MIL-R-6106/9C(USAF)
AMENDMENT 3
12 December 1996
SUPERSEDING
AMENDMENT 2
1 October 1993

MILITARY SPECIFICATION SHEET

RELAY, ELECTROMAGNETIC, CONTINUOUS DUTY, 60 AMP,
3PDT, ENVIRONMENTALLY SEALED

FIGURE 1. Configurations and dimensions.

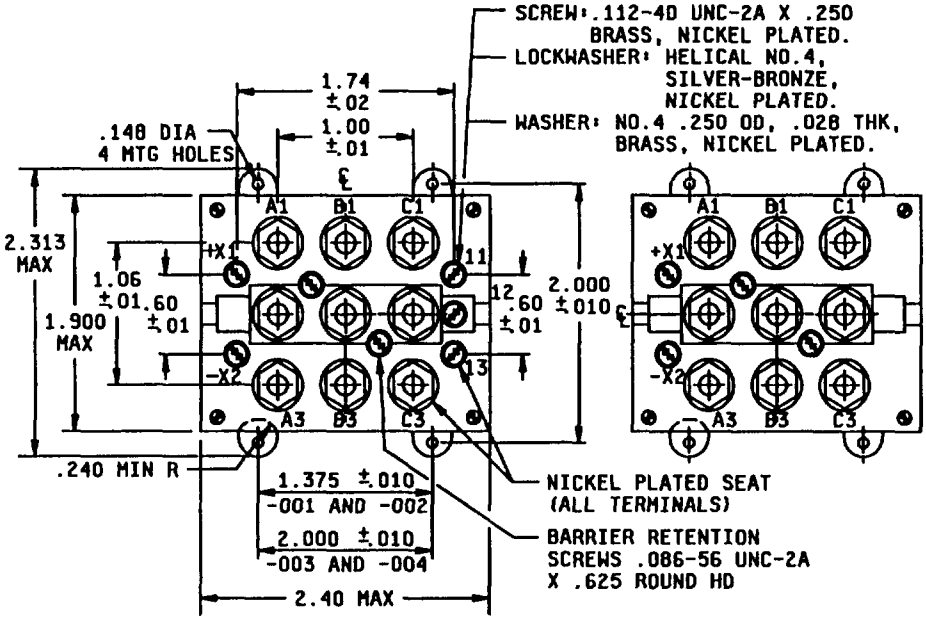
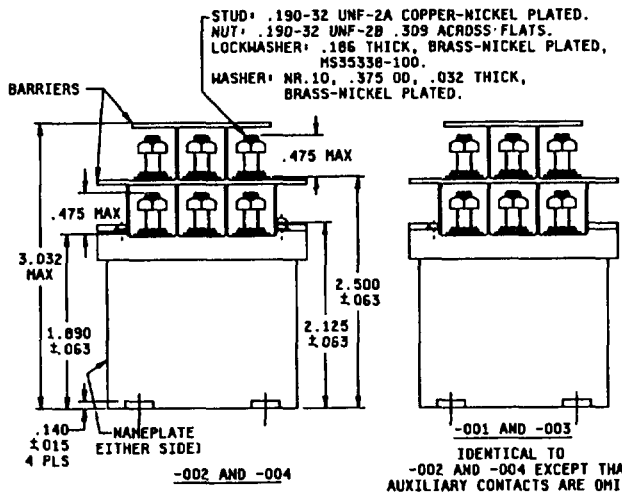
* FIGURE 1, delete and substitute:
